Access Compliance Report

Public Rights-of-Way

(Curb Ramps)

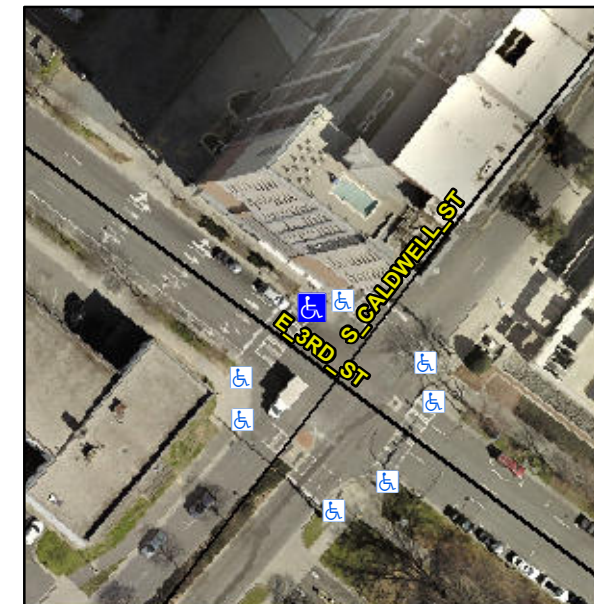
Intersection ID: 12863	Main Street: E_3RD_ST	Cross Street: S_CALDWELL_ST	Location: NW
ADA ID: 5F365A4BDE21	Ramp Type: Perp	Initial Pass/Fail: Fail	Overall Compliance: No
Severity Score: 13.75			
Codes/Mitigation Info/Possible Solution		Field Measurements/Component Compliance

Not Found, R304.2.2, R304.5.3

Compliance	Description	Data	Compliance	Description	Data
N/A	Ramp Length (in)	72.0	No	Ramp Slope (%)	8.9
Yes	Ramp Width (in)	48.0	No	Ramp XSlope (%)	2.9
N/A	Flare Type LT	N/A	N/A	Flare Type RT	N/A
N/A	Flare Slope LT (%)	N/A	N/A	Flare Slope RT (%)	N/A
N/A	Flare Traversable LT?	N/A	N/A	Flare Traversable RT?	N/A
N/A	Landing Length (in)	N/A	N/A	DWS Provided?	N/A
N/A	Landing Width (in)	N/A	N/A	DWS Contrast?	N/A
N/A	Landing Slope (%)	N/A	N/A	DWS Length (in)	N/A
N/A	Landing X Slope (%)	N/A	N/A	DWS Full Width?	N/A
N/A	Landing Curb? (Y/N)	N/A	N/A	DWS Offset (in)	N/A
N/A	Shared Landing?	N/A			
N/A	Gutter Ponding?	N/A	N/A	Gutter Slope (%)	N/A
N/A	Gutter Lip Ht (in)	N/A	N/A	Gutter X Slope (%)	N/A
N/A	Painted X Walk1?	Yes	N/A	Painted X Walk2?	N/A
	X Walk 1 Direction	To SW		X Walk 2 Direction	N/A
N/A	X Walk 1 Width (in)	115.0	N/A	X Walk 2 Width (in)	N/A
	X Walk 1 Slope (%)	3.8		X Walk 2 Slope (%)	N/A
	X Walk 1 X Slope (%)	1.7		X Walk 2 X Slope (%)	N/A

Remove & Replace Entire Ramp.
